APPLICATION NO.	FILING DATE	FIRST NAMED INVENTOR	ATTORNEY DOCKET NO.	CONFIRMATION NO.
10/812,370	03/29/2004	Andrew J. Tobler	IMI 40008	7611

NON-FINAL OFFICE ACTION

2. Restriction to one of the following inventions is required under 35 U.S.C. 121:
- I. Claims 1-9, drawn to an agitator apparatus, classified in class 366, subclass 325.4.
 - II. Claims 10-22, drawn to a method of fabricating an agitator, classified in class 29, subclass 889.7.
3. The inventions are distinct, each from the other because of the following reasons:
4. Inventions II and I are related as process of making and product made. The inventions are distinct if either or both of the following can be shown: (1) that the process as claimed can be used to make other and materially different product or (2) that the product as claimed can be made by another and materially different process (MPEP § 806.05(f)). In the instant case, the product as claimed can be made by another and materially different process such as by casting or molding.

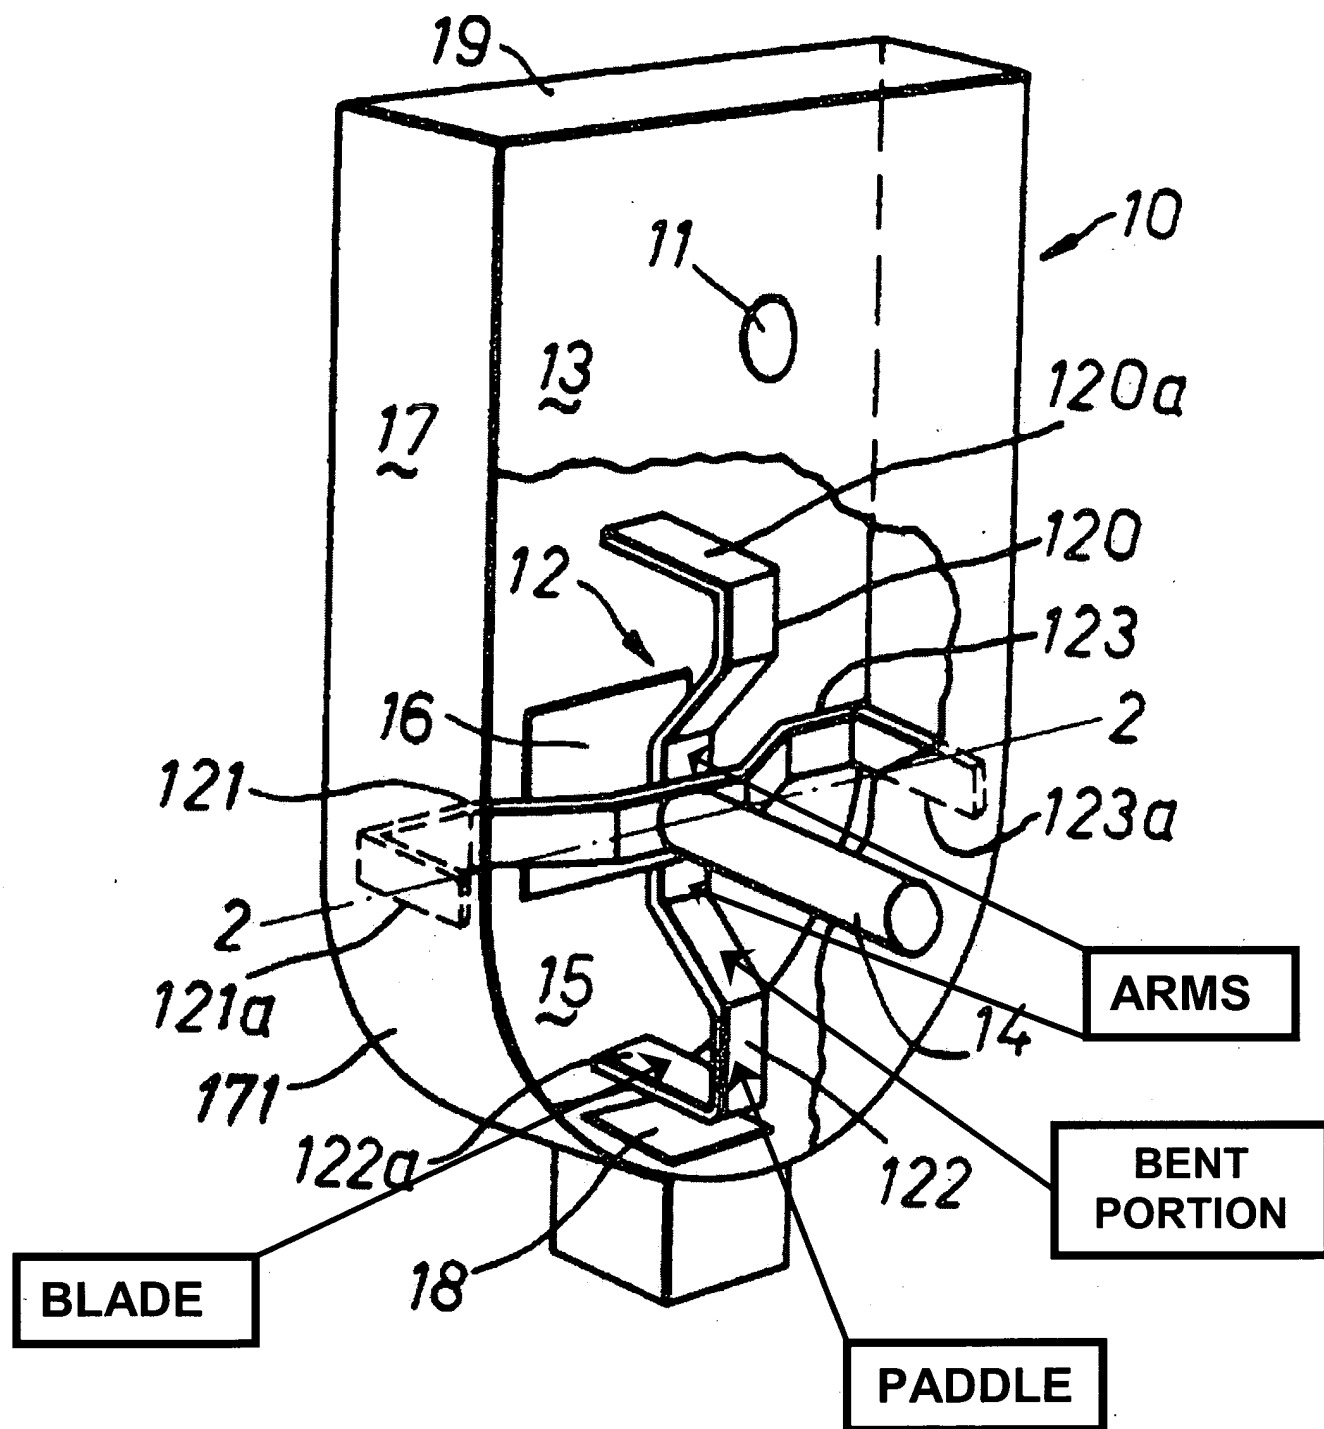
14. Claims 1, 2, 4, 5, 7, and 8 are rejected under 35 U.S.C. 102(b) as being anticipated by Kramer (US 4,087,079).

The patent to Kramer discloses the recited agitator as seen below including arms; hub 14; paddles 120, 122 attached to the arms by bent portions; blades 120a, 122a extending in a transverse direction out of a plane of the arms.

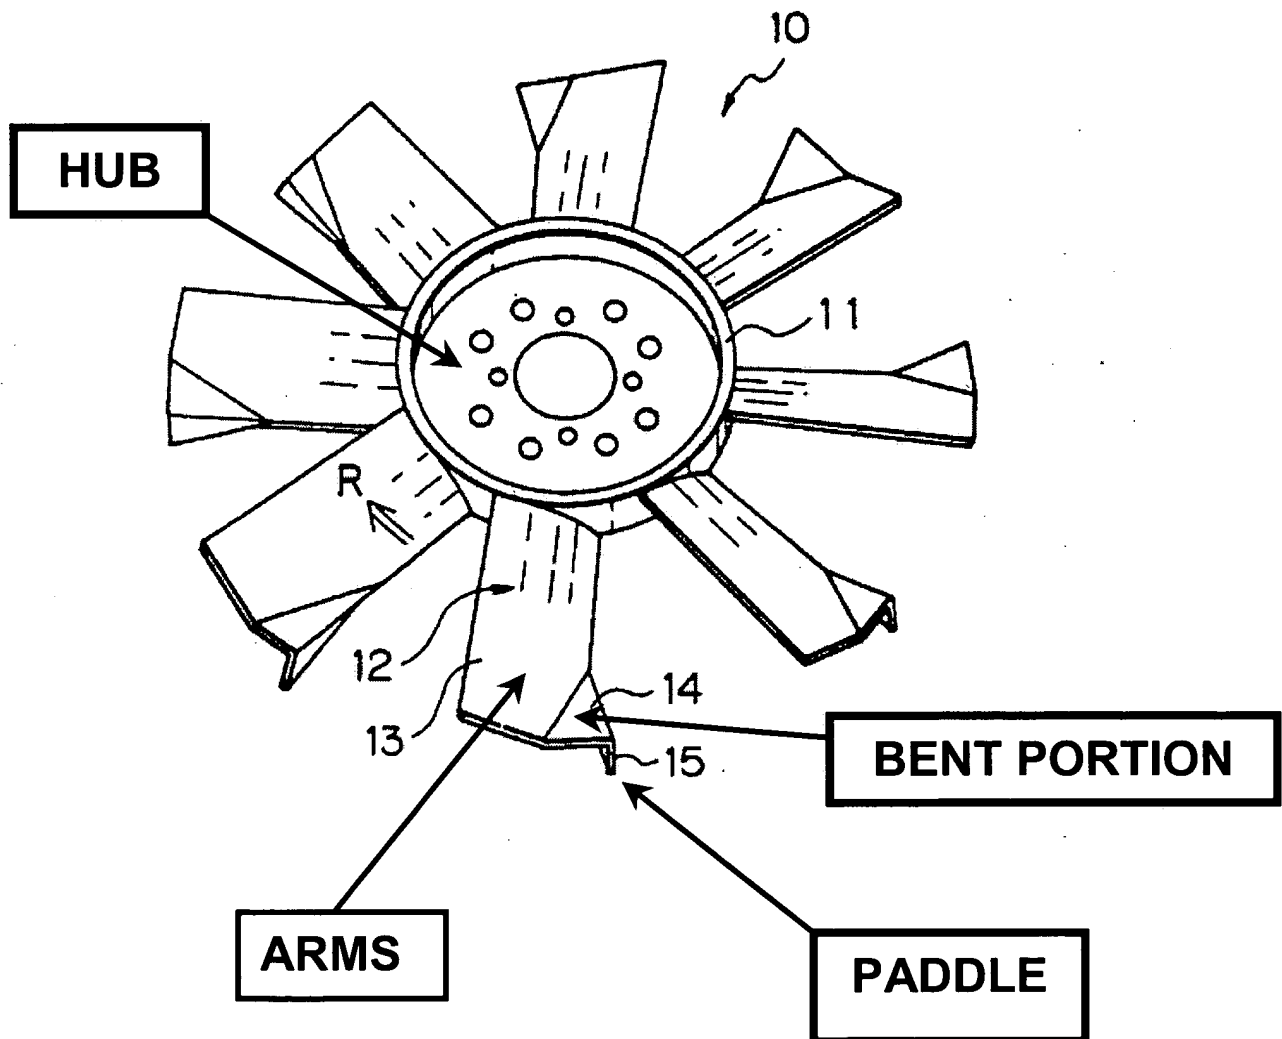
15. Claims 1 and 4 are rejected under 35 U.S.C. 102(b) as being anticipated by Mita (US 5,226,783).

The patent to Mita discloses the recited agitator as seen below including arms 13; hub; and paddles 15 attached to the arms by bent portions 14.

Fig. 4

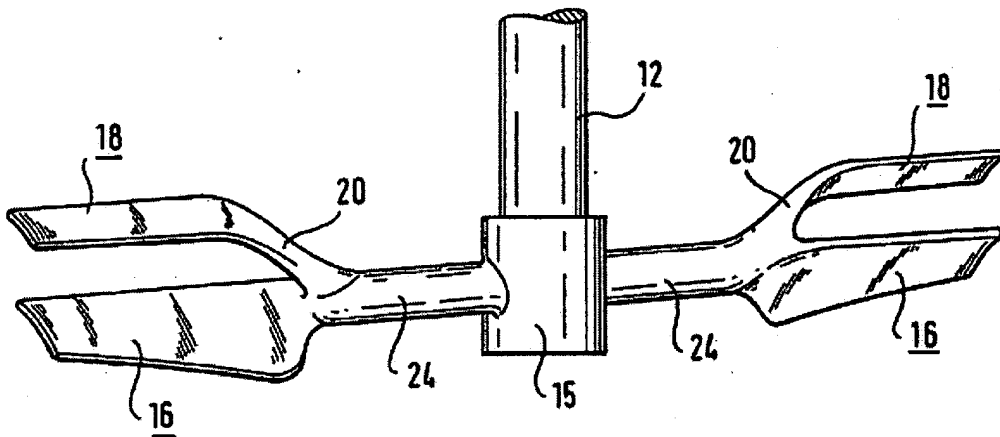
16. Claims 1, 2, 4, 5, 7, and 8 are rejected under 35 U.S.C. 102(b) as being anticipated by DE 3730423 A1.

DE 3730423 A1 discloses the recited agitator as seen below including arms 24; hub 15; paddles 18 attached to the arms by bent portions 20; and blades 16 extending in a direction out of a plane of the arms.
